THE BELT RAILWAY COMPANY OF CHICAGO

System General Order

#2025-001

Subject: System General Order #2025 - 001

ITEM 11 – BRC SPEED SIGNALS (TTSI Page 74)

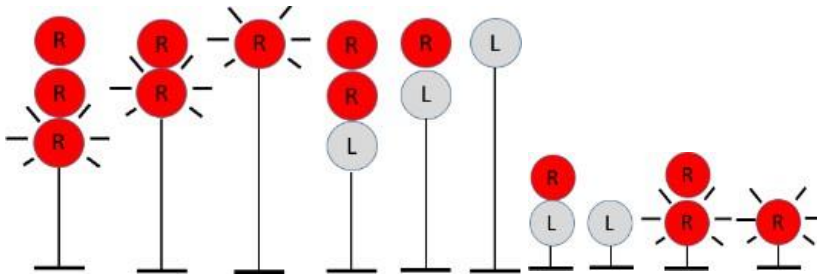
Where RESTRICTING signals are displayed, these will utilize flashing red aspects in accordance with BRC SSI Rule 9.1.3, RESTRICTING.

Where RESTRICTING signals are displayed, these will utilize flashing red aspects in accordance with BRC SSI Rule 9.1.3, RESTRICTING.

S20.5.4 Understanding Between Crew Members Before Fouling Equipment (Three-Point Protection)

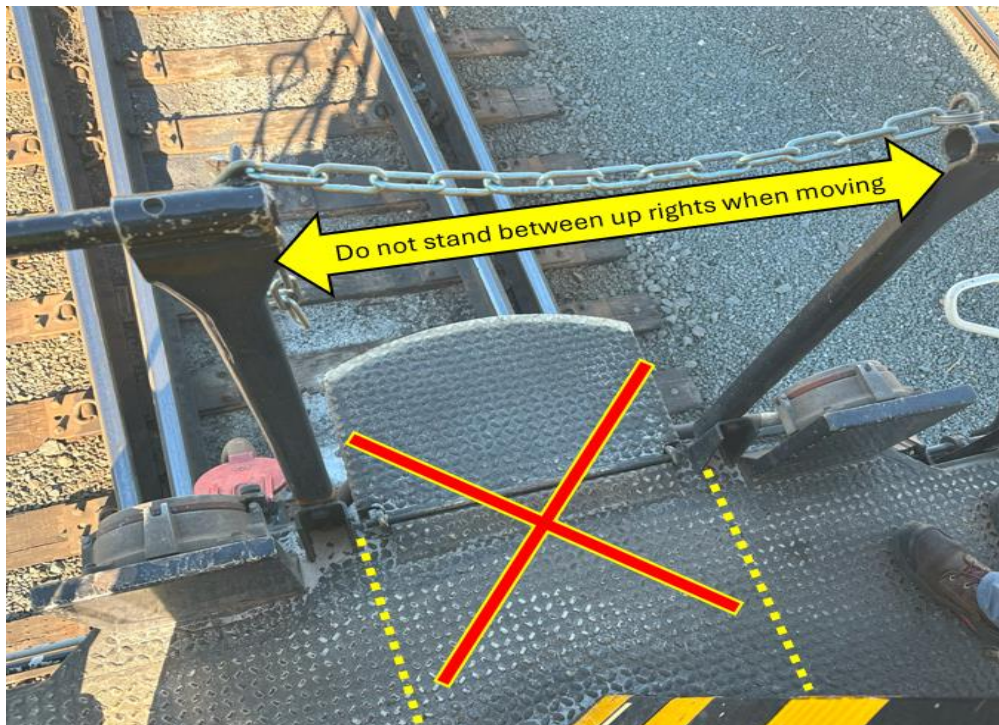
Remove the following Bullet Point:

- The employee must notify all crew members. However, notification is not required when the primary RCO opens knuckles during switching operations.

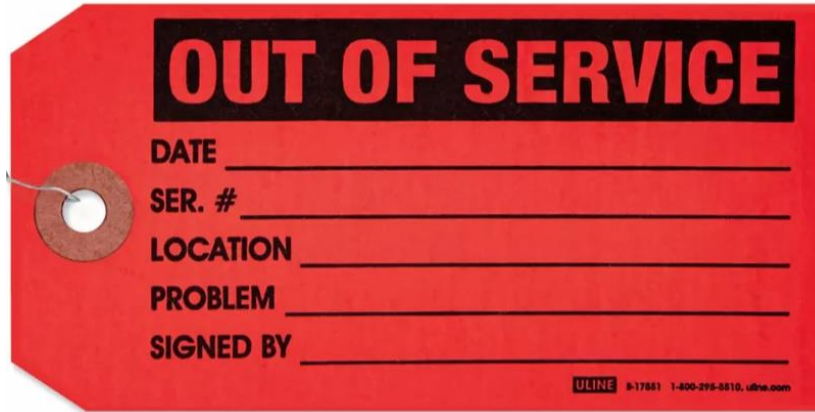
When traversing turnouts or crossovers, employees must not ride cars more than 60 feet in length on the side next to equipment on an adjacent track.
